RESOLUTION SETTING HEARING ON APPEAL OF LARRY KUEL (OWNER) ON A DENIAL OF TYPE 2 DESIGN ALTERNATIVES FOR A PUBLIC HEARING SITE PLAN FOR PROPERTY LOCATED AT 4424 SOUTHEAST 14TH STREET

(SITE-2023-000059)

Communication from the City Plan and Zoning Commission advising that at their July 20, 2023 meeting, the following action was taken regarding a request from Larry Kuel (owner) for review and approval of a Public Hearing Site Plan "Donna's Garage," for property located at 4424 Southeast 14th Street, and for the following denied Type 1 Design Alternatives in accordance with City Code Sections 135-9.2.4(B) and 135-9.3.1(B):

DONNA'S GARAGE
 4424 SE 14TH ST
 DES MOINES, IA

C-102 - DEMO SHEET

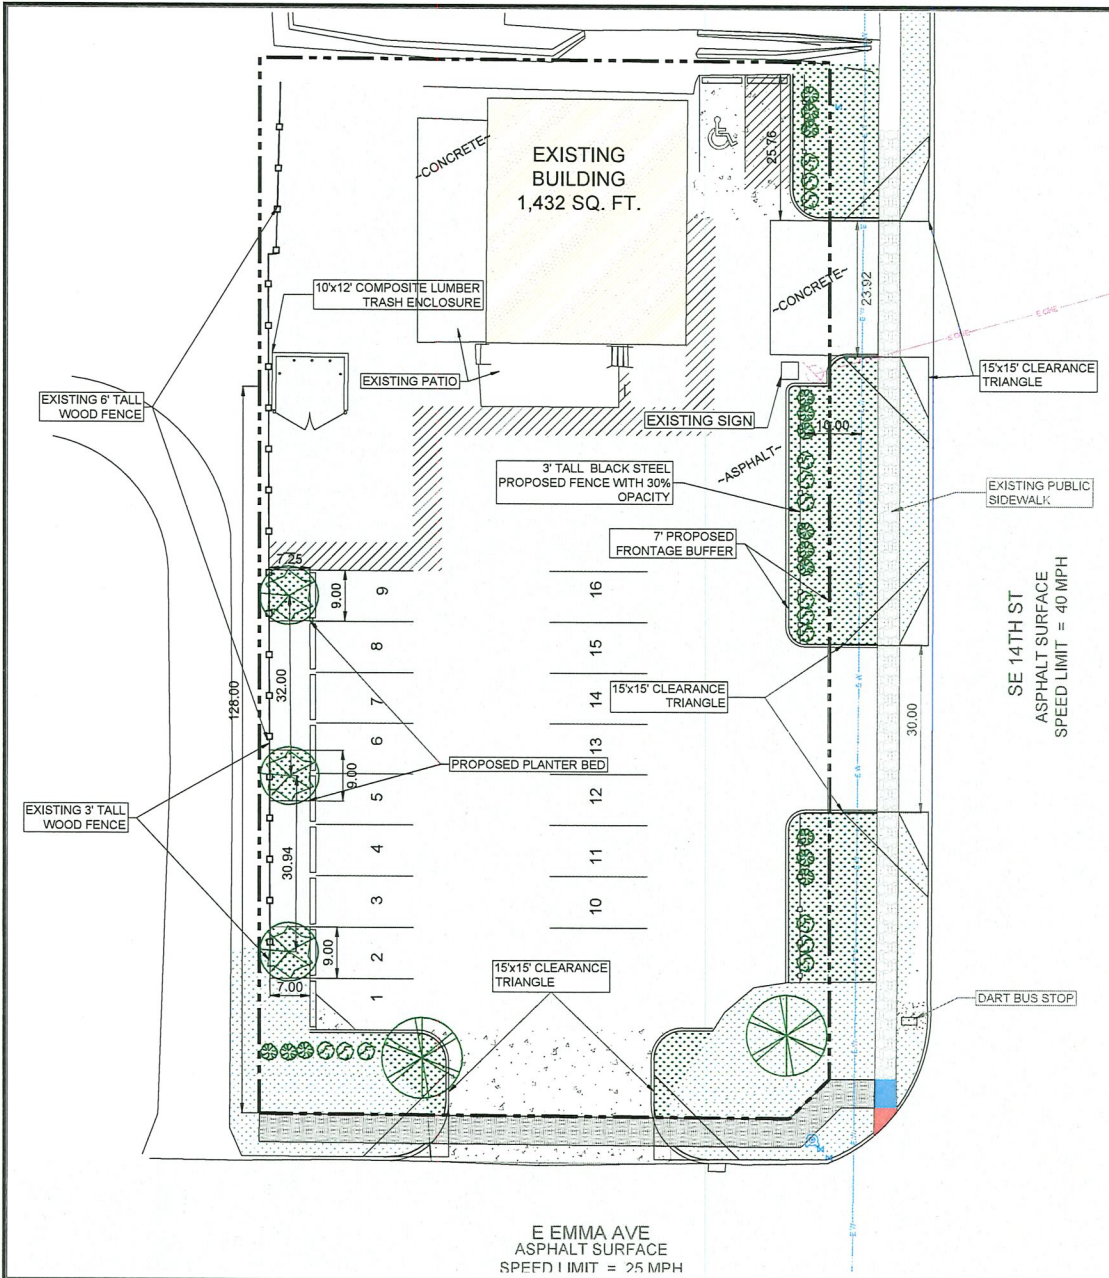
Compliance with all applicable Sections of Chapter 135 is required with any Site Plan submittal. Removal of the 2 driveways off of Southeast 14th Street and their restoration to a traditional curb-and-gutter configuration is a City requirement, and doing so would bring the site into compliance with the site design standards of Chapter 135 of City Code.

One of the proven countermeasures to high-volume and severe crash rates is corridor access management. Removing drive accesses at this location is an example of corridor access management. Closure of the 2 driveway accesses off of Southeast 14th Street and their restoration to a traditional curb-and-gutter configuration would significantly increase visibility and safety by reducing conflict points for all users (drivers, pedestrians, transit riders, and cyclists).

- Removal of pavement within the right-of-way and private property so a paving setback is established adjacent to Southeast 14th Street (one already exists adjacent to Emma Avenue), pursuant to City Code Section 135-7.7.2.A.
- A row of ornamental grasses or shrubs and overstory trees planted at 30-foot intervals within this paving setback (on both frontages) to meet the intent of street tree and parking lot buffering requirements described in City Code Sections 135-7.5.3.C.1 and 135-7.7.2.
- Interior parking lot tree plantings that meet the intent of the parking lot shading requirements described in City Code Section 135-7.9.2.B.4.

C-106 - LANDSCAPING SHEET

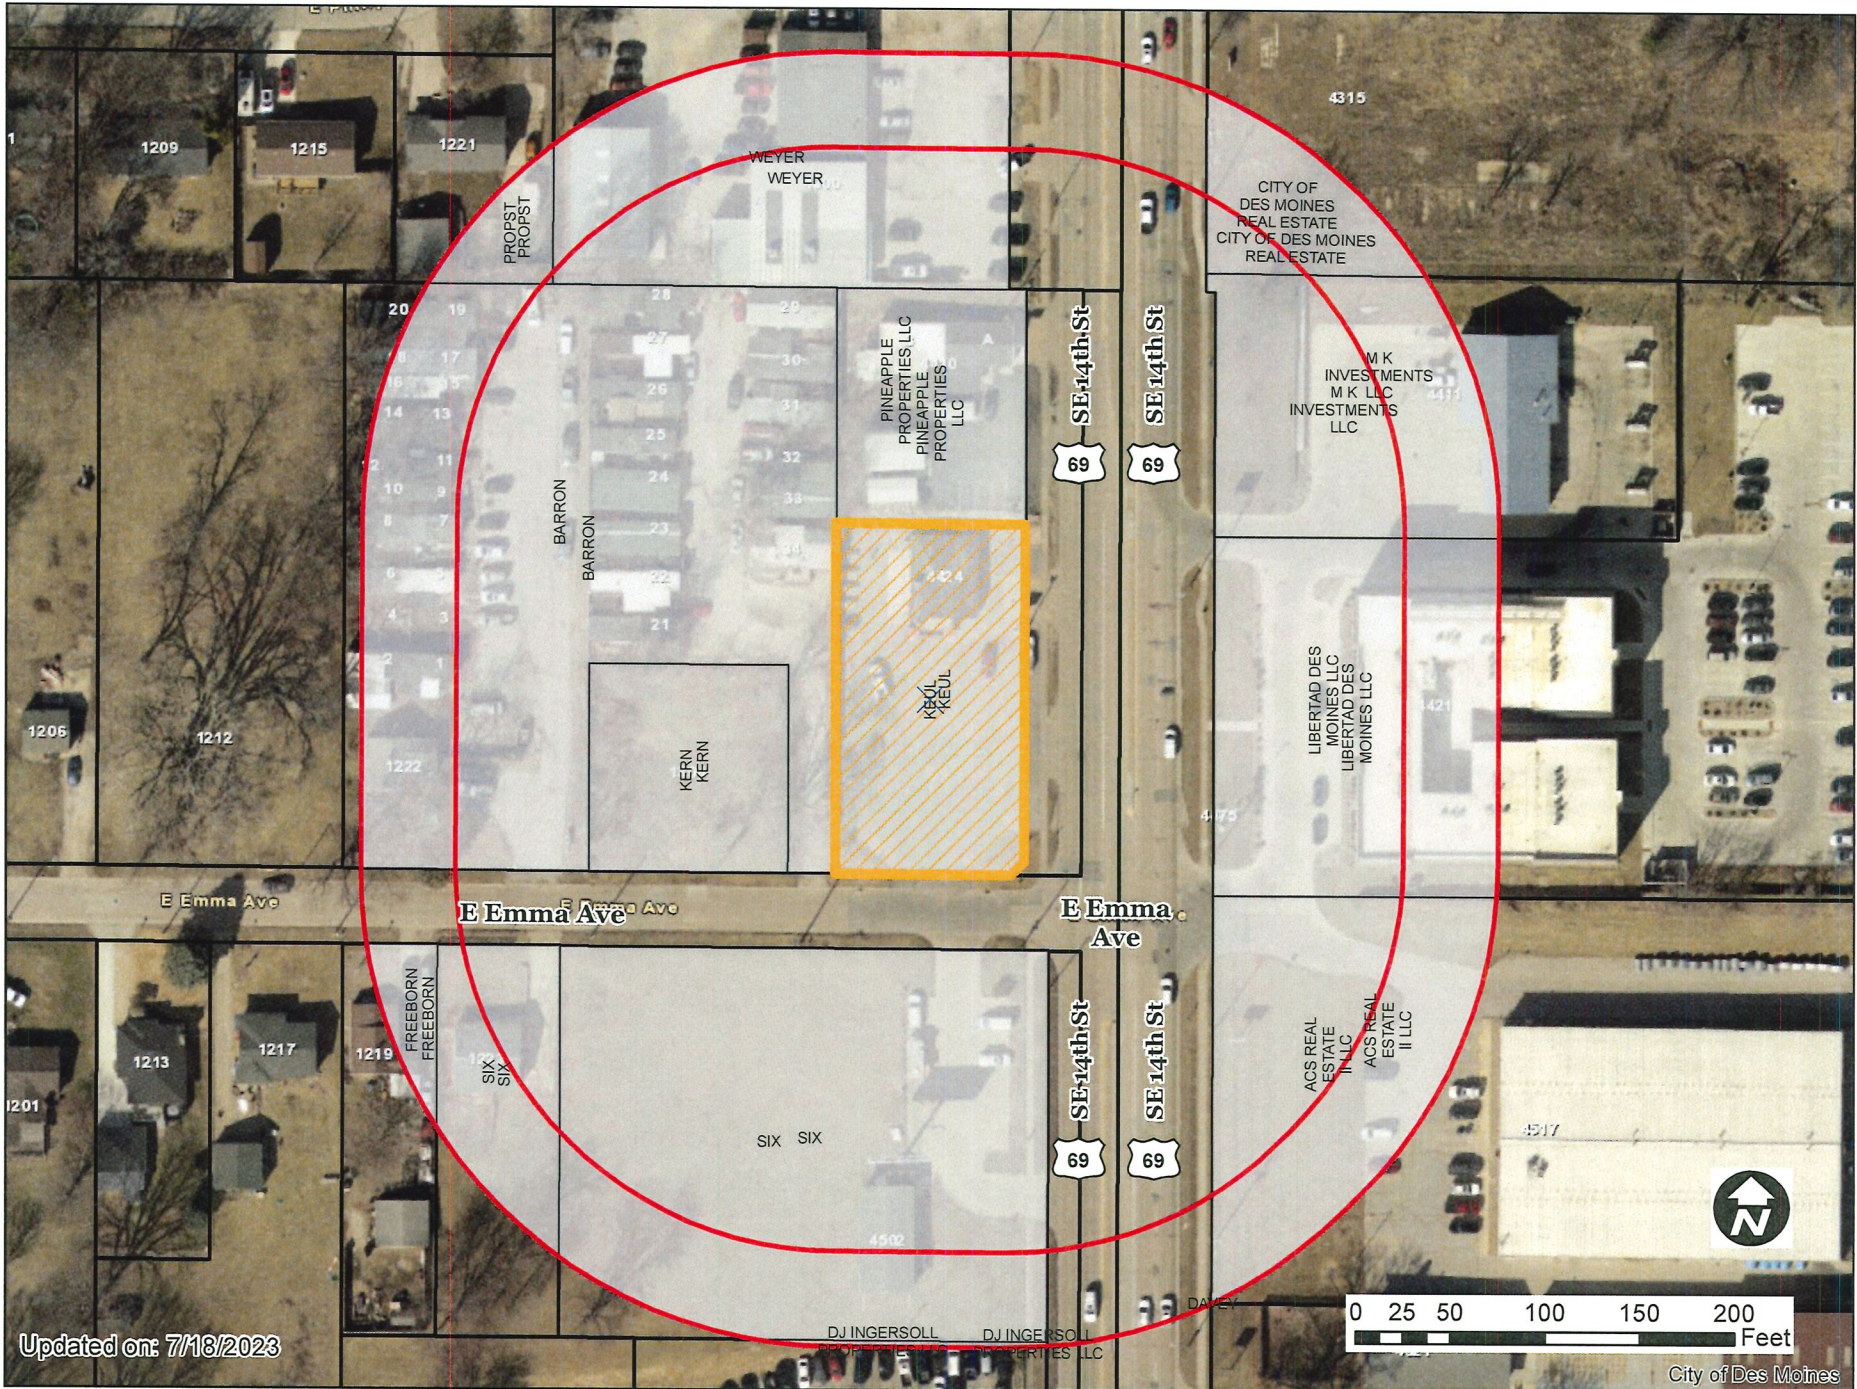
With the exception of some trees and shrubs proposed at the southern edge of the site around the Emma Avenue drive access, the applicant is requesting a waiver of landscaping requirements.

Based on the information above, the extent of the newly-requested waivers of landscaping requirements is not appropriate at this site.

Carol Maher asked about the note on the site plan indicating use of washed river rock stone.

Wally Pelds indicated that they could change that if not allowed.
